Docket No.: 0114089.00120US2

FATIGUE RELIEVING SUPPORT FOR STEERING WHEELS AND THE

LIKE

CORRECTED APPEAL BRIEF UNDER 37 C.F.R. §41.37

ATTACHMENT 1

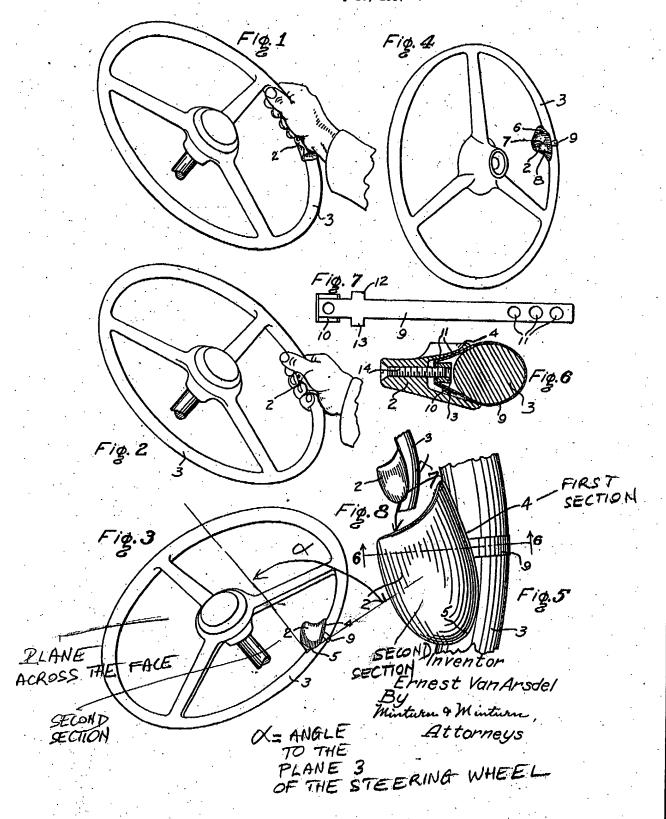
a second section 2 (i.e., upward section in Figs. 3 and 5) that connects to and extends from the first section 4 at the peripheral portion 3 of the steering wheel 3, the second section 2 extends from the first section 4 outward at an angle (see angle α in Figs. 3 and 5 of the Attachment 1) to a plane (Att. 1) across a face to the steering wheel 3, with the second section 2 inherently for supporting at least a portion of a vehicular operator's body (e.g., the hand as seen

In relying on Van Arsdel, the Examiner does not cite to any descriptions of the auto steering wheel handgrip disclosed in this reference but annotates the drawings for this purpose. Specifically, the Examiner annotated Figures 3 and 8 in an attempt to show what is being claimed in claim 20. The Examiner indicates that what is shown at reference no. 4 equates to the first section in claim 20 and what is shown at reference no. 2 equates to the second section in that claim. Applicant believes that the Examiner fails to appreciate the description of the auto steering wheel handgrip that is described in Van Arsdel. Van Arsdel at column 2, lines 13-40 states:

A review of Figures 3 and 5 as annotated by the Examiner to attempt to show that the auto steering wheel handgrip of Van Arsdel is disposed outward at an angle α to a plane across the face of the steering wheel shows that the Examiner's position is

misplaced. As the description above from Van Arsdel indicates, the auto steering wheel handgrip is disposed as shown in Figure 6 parallel to the plane across the face of the steering wheel not at angle to it. This is very clear because in each disposition of the auto steering wheel handgrip in the Figures, the handgrip is fixed in this parallel plane to support the thumb or part of the palm. It is also fixed so that it is not deformable so the driver can put extensive pressure on it (and it will not move) for steering the automobile (see underscored sections in the quotation above).

If the handgrip was supposed to be at an angle α as the Examiner contends, the disposition of the handgrip would be shown differently in the drawings. As such, there is not support for the Examiner's contention that the handgrip is disposed other than in the plane parallel to the plane across the form of the steering wheel. Accordingly, one skilled in the art would not understand the auto steering wheel handgrip in Van Arsdel to be disposed as the Examiner contends. Moreover, there is no support in the description of the auto steering wheel handgrip in Van Arsdel that it will deform in any way out of interference with the operation of the steering wheel. Applicant submits he is justified in taking this position given the description of the connection of the hand grip as shown in Figure 6 or the integrally formed handgrip shown in Figure 8. Therefore, the auto steering wheel handgrip of Van Arsdel would not anticipate the invention as set forth in claim 20. Specifically, Van Arsdel at least does not teach or suggest the features of the second section being disposed outward at an angle from the plane across the face of the steering wheel and the handgrip of Van Arsdel does not deform as set forth in claim 20.

ATTACHMENT 2

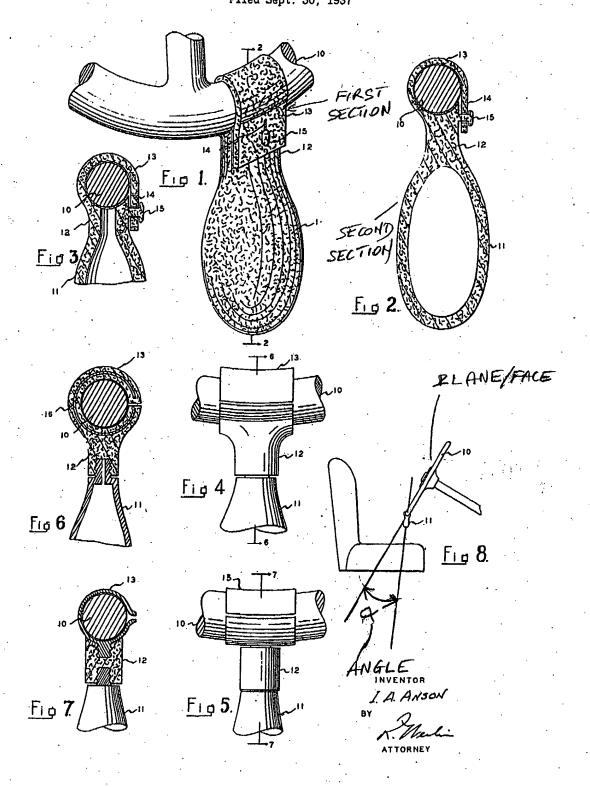
a first section 13 that connects to a peripheral portion of the steering wheel 10; a second section 11 extends from the first section at the peripheral portion of the steering wheel 10, the second section 11 extends from the first section 13 outward at an angle (see angle α in Fig. 8 of Attachment 2) to a plane (Att. 2) across a face (Att. 2) to the steering wheel 3, the second section 11 inherently for supporting at least a portion of a vehicular operator's body (e.g., the hand) when pressure from the portion of the vehicular operator's body on the second section 11 is less than the pressure for deforming the second section 11 out of interference with the vehicular operator's ability to operate the steering wheel 10, and deforming out of interference with the vehicular operator's ability to operate the steering wheel 10 when pressure from the portion of the vehicular operator's body on the second section 11 is equal to or greater than the pressure for deforming the second section 11 out of interference with the vehicular operator's ability to operate the steering wheel 10.

The Examiner has rejected claims 20-26 and 28/20 for anticipation based on Anson. Referring to the Figures of Anson, the Examiner has indicated that reference no. 13 equates to the first section recited in claim 20 and reference no. 11 equates to the second section of the claim. The Examiner has annotated Figure 8 to indicate that the steering wheel attachment of Anson is disposed at an angle α with respect to a plane across the face of the steering wheel. Before addressing the Examiner's basis of rejection, Applicant submits that the description of the steering wheel attachment of Anson is germane to the Examiner's position on anticipation. Applicant also submits that if this description is taken into consideration, the Examiner should withdraw the anticipation rejection based on Anson.

Given the foregoing, the steering wheel attachment of Anson at least does not teach the features of the second section being disposed <u>outward</u> at an angle from the plane across the face of the steering wheel (Anson extends rearward) and it does not

C. E. E. LAUBACH
STEERING WHEEL
Filed July 13, 1925

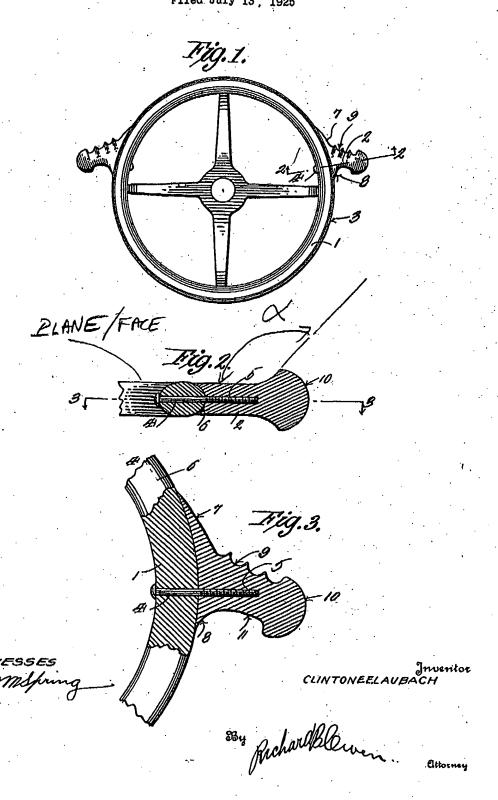
a second section 10 that connects to, and extends from, the first section 7, 8 at the peripheral portion of the steering wheel 1, the second section 10 extends from the first section 7, 8 outward at an angle (see angle α in Fig. 2 of the Attachment 3) to a plane (Att. 3) across a face

The Examiner has rejected claims 20, 27, and 28/27 for anticipation based on Laubach. In formulating the rejection based on Laubach, the Examiner has not relied on any part of the disclosure in that patent but has annotated the drawings to allegedly show that Laubach teaches each and every feature of claim 20. The Examiner has indicated that reference nos. 7 and 8 of the knob 2 equates to the first section of claim 20 and reference no. 10 equates to the second section of this claim. Applicant submits that the Examiner's reliance on Laubach is misplaced.

The description of the knobs in Laubach make plain that the Examiner's position of anticipation based on this reference is also misplaced. First, the knobs of Laubach are rigidly connected to the steering wheel by the screws 5. As such, the knobs are meant remain in place in operation. This location is in a plane parallel to the plane across the face of the steering wheel.

The Examiner has annotated the drawings to attempt to show that enlarged head 10 is disposed outward at an angle from the plane across the face of the steering wheel. This is not supported.

FIG. 4

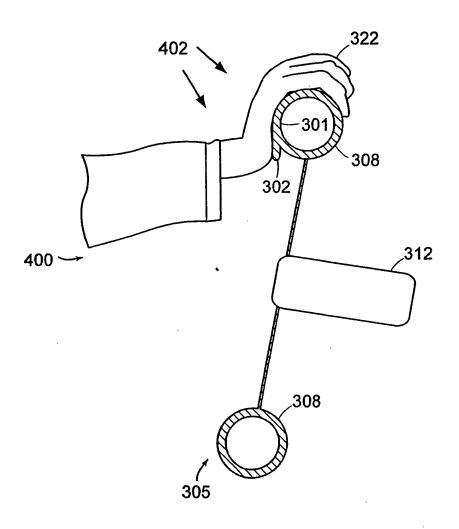
A significant aspect of the present invention is that the second section will deform out of interference with the operation of the steering wheel if it is grabbed in an emergency. This is shown graphically in Figure 4. The result is a novel apparatus that relieves or prevents fatigue when driving for extended periods of time but does not prevent the driver from grabbing the wheel in emergencies.

ATTACHMENT 1

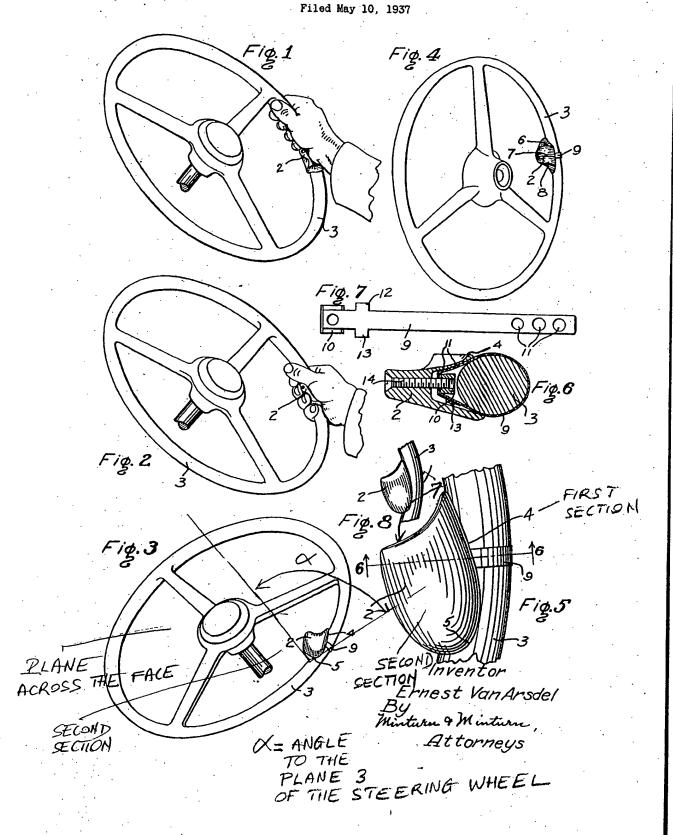
a second section 2 (i.e., a concave upward section in Figs. 3 and 5) that connects to and extends from the first section 4 at the peripheral portion 3 of the steering wheel 3, the second section 2 extends from the first section 4 outward at an angle (see angle α in Figs. 3 and 5 of the Attachment 1) to a plane (Att. 1) across a face to the steering wheel 3, with the second section 2 inherently for supporting at least a portion of a vehicular operator's body (e.g., the hand as seen in Figs. 1 and 2) when pressure from the portion of the vehicular operator's body on the second section 2 is less than the pressure for deforming the second section 2 out of interference with the vehicular operator's ability to operate the steering wheel 3, and deforming out of interference with the vehicular operator's ability to operate the steering wheel when pressure from the portion of the vehicular operator's body on the second section is equal to or greater than

steering wheel rim 3 in a manner to slope downwardly and inwardly of the rim. The outer edge 4 of the side, and 5 of the rear end of the *concave*, located above the rim, *extends up into a marginal flange* to be contacted by the inside of the ball of the thumb or by the bottom of the hand, depending upon which part of the hand is seated to rest." See also Arsdel's claims 1 and 2. Arsdel's concave upward section 2 extends from the first section 4 outward at an angle α to the plane across the face of the steering wheel as seen in Figs. 3 and 8 of Attachment 1. Therefore, Arsdel's concave upward section 2 in Fig. 3 of Arsdel "reads on" Applicant's claimed second section.

A review of Figs. 3 and 5 as announced by the Examiner to attempt to show that the auto steering wheel handgrip of Van Arsdel is disposed at an angle α to a plane across the face of the steering wheel shows that the Examiner's position is misplaced. As the description above from Van Arsdel indicates, the auto steering wheel handgrip is disposed as shown in Figure 6 parallel to the plane across the face of the steering wheel not at angle to it. This is very clear because in each disposition of the auto steering wheel handgrip in the Figures, the handgrip is fixed in this parallel plane to support the thumb or part of the palm. It is also fixed so that it is not deformable so the driver can put extensive pressure on

ATTACHMENT 2

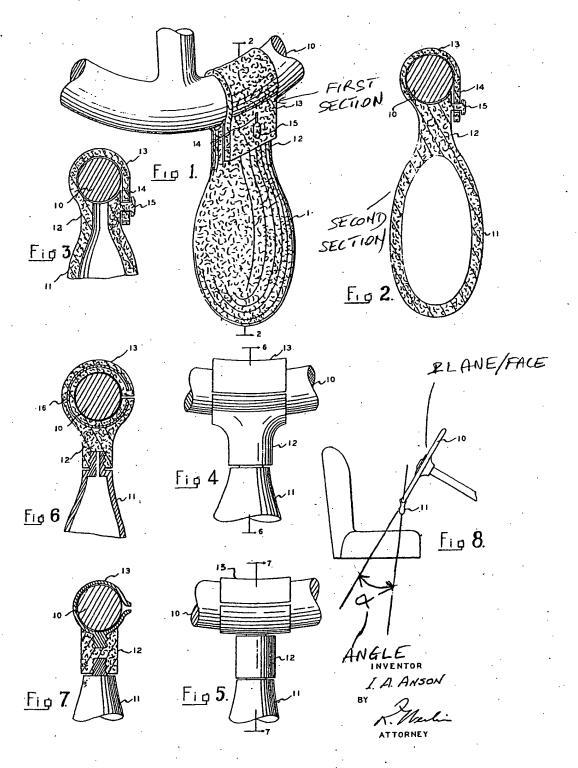
a second section 11 extends from the first section at the peripheral portion of the steering wheel 10, the second section 11 extends from the first section 13 outward at an angle (see angle α in Fig. 8 of Attachment 2) to a plane (Att. 2) across a face (Att. 2) to the steering wheel 3, the second section 11 inherently for supporting at least a portion of a vehicular operator's body (e.g., the hand) when pressure from the portion of the vehicular operator's body on the second section 11 is less than the pressure for deforming the second section 11 out of interference with the vehicular operator's ability to operate the steering wheel 10, and deforming out of interference with the vehicular operator's ability to operate the steering wheel 10 when pressure from the portion of the vehicular operator's body on the second section 11 is equal to or greater than the pressure for deforming the second section 11 out of interference with the vehicular operator's ability to operate the steering wheel 10.

outward such that the second section 11 is at an angle from the plane across the face of the steering wheel and out of interference with the operation of the steering wheel as claimed. On the other hand, it is well settled that a claim containing a "recitation with respect to the manner in which a claimed apparatus is intended to be employed does not differentiate the claimed apparatus from a prior art apparatus" if the prior art apparatus teaches all the structural limitations of the claim. *Ex parte Masham*, 2 USPQ2d 1647 (Bd. Pat. App. Inter. 1987) and MPEP 2114. In the case at hand, Anson teaches all structural limitations in the claims, therefore, Applicant's contention regarding the manner in which the claimed device is intended to be employed is unpersuasive.

Third, in the same vein of arguments, Applicant argued: "the steering wheel attachment of Anson at least does not teach the features of the second section being disposed <u>outward</u> at an angle from the plane across the face of the steering wheel (Anson extends rearward) and it does not teach that the attachment would deform out of interference with the operation of the steering wheel as set forth in claim 20."

C. E. E. LAUBACH

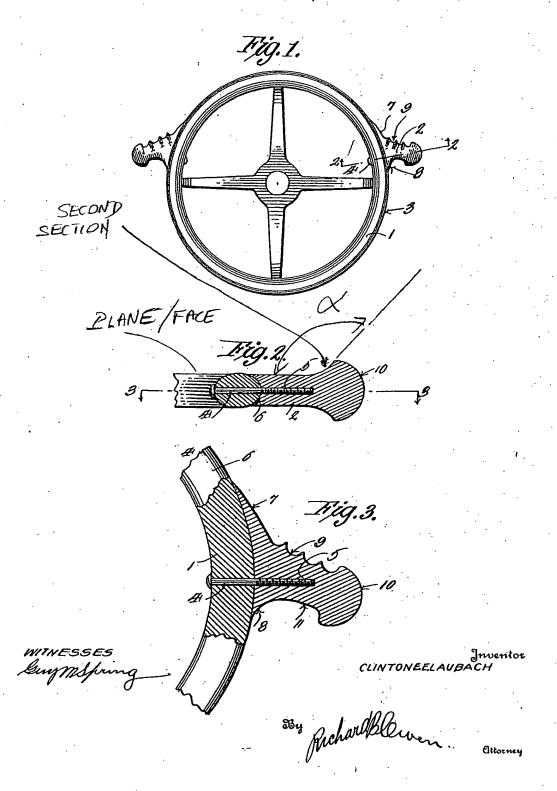
a second section 10 that connects to, and extends from, the first section 7, 8 at the peripheral portion of the steering wheel 1, the second section 10 extends from the first section 7, 8 outward at an angle (see angle α in Fig. 2 of the Attachment 3) to a plane (Att. 3) across a face (Att. 3) to the steering wheel 1, the second section 10 inherently for supporting at least a portion of a vehicular operator's body (e.g., the hand) when pressure from the portion of the vehicular operator's body on the second section 10 is less than the pressure for deforming the second section 10 out of interference with the vehicular operator's ability to operate the steering wheel 1, and deforming out of interference with the vehicular operator's ability to operate the steering

Applicant further asserted that the Examiner's drawings to attempt to show the enlarged head 10 is disposed outward at an angle from the plane across the face of the steering wheel is unsupported. Applicant's instant assertion is in direct conflict with the substantial evidence presented in Laubach's Fig. 2. This Fig. 2 shows that the second section of Laubach forms an angle with the face of the steering wheel as seen in Attachment 3. Note that things clearly shown

Finally, Applicant averred that the knob of Laubach does not deform out of interference with the operation of the steering wheel as set forth in claim 20. The Examiner respectfully submits that the driver can unscrew Laubach's screws 5, and then screw or fasten the screws 5 at other position on the rim 6 of the steering wheel such that the new position is out of interference with the operation of the steering wheel as the driver so desires. The operation to adjust or change the position of Laubach's handgrips is similar to the operation to adjust the handgrip of Arsdel since both Laubach and Arsdel use the screws as the fastening means. Since the position of Laubach's knobs is capable of being changed to be out of interference with the operation of the steering wheel, *i.e.*, Laubach's knobs can inherently performed the functions recited in Applicant's claim, therefore, Applicant's claims are anticipated by Laubach. *In re Schreiber* and *Ex parte Masham, supra*.
